UNITED STATES PATENT AND TRADEMARK OFFICE

Office Action Summary

10/633,167

DETAILED ACTION

Figure 1: Fig. 3 of Moa et al.

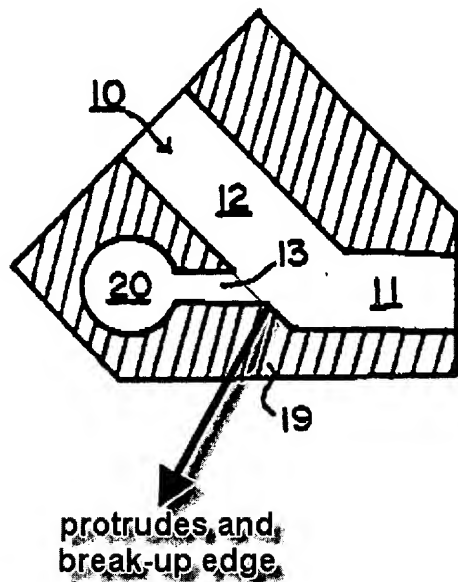
9. Claims 5-8, and 10 are rejected under 35 U.S.C. 103(a) as being unpatentable over Moa et al. (US 5193532). As shown in figure 1, after drawing a straight line, it can be seen that the pipe extends slightly outward on the bottom portion. Therefore, it can be considered obvious that this pipe is inserted into the second opening 13 and protrudes into the inside of the hollow body 19A (See illustration fig. 1 below). As for claim 6, it can also be seen in the figure that the pipe protrudes so far into the inside of the hollow body 19A that it forms a break-up edge for the respiratory gas flow directed into the hollow body (See illustration fig. 1 below). As for claim 7, the device of Moa et al. has shown that the pipe connected between 20 and 13 is fully capable of being plugged as well as another pipe can be plugged into this pipe.

Figure 2: Fig. 5 of Moa et al.

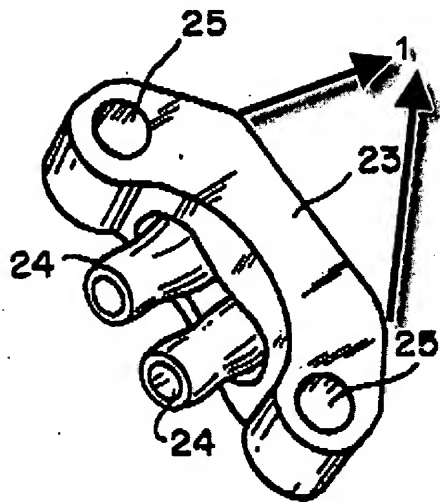
11. For claim 10, it can be seen in the figure below that the attachment piece 23 consists of a stopper 1 (see fig. 2 below) which can be partially inserted into the hollow body 19A at the end surface as further shown in figure 6. A stopper can be considered anything preventing the attachment piece from moving further into the hollow body 19A. The angular sections of the attachment are partially inserted into hollow body 19A and prevent further movement into the hollow body 19A.
